## **TECHNICAL MEMORANDUM**

Review of DRAFT: Investigation of Ground Water Contamination near Pavillion Wyoming

Prepared by the Environmental Protection Agency, Ada OK

Prepared by: Tom Myers, Ph.D.

Figure 1: Snapshot from EPA (2011) Figure 3 showing frequency of depth for gas wells (top), surface casing for gas wells, and base of domestic wells.

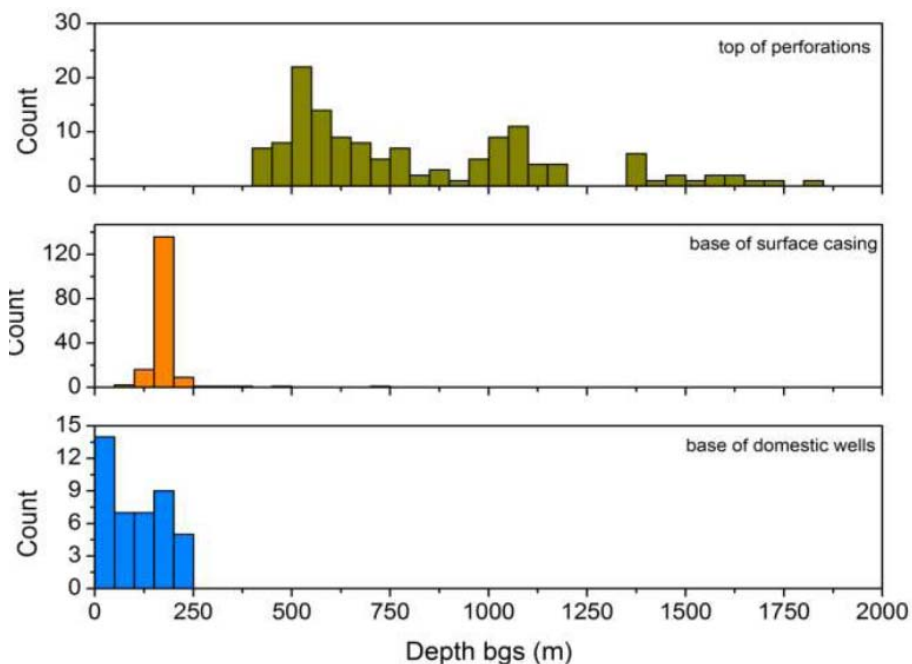
Figure 1 (EPA Figure 3) shows that domestic water wells in the regions are screened at all levels down to about 250 m, or more than 800 feet, with half of the wells being deeper than 300 feet, similar to the depths found by Daddow (1996) in other areas of the aquifer. However, the EPA states the information source was from the State Engineer *and* homeowner interviews (EPA p 2). It is unclear whether both were used for each well. It is my experience that homeowners have a poor concept of the depth of their well unless they have paperwork that documents it.

*Recommendation: The EPA should provide more information about the source of its water well construction data, showing it in EPA Table A1.*
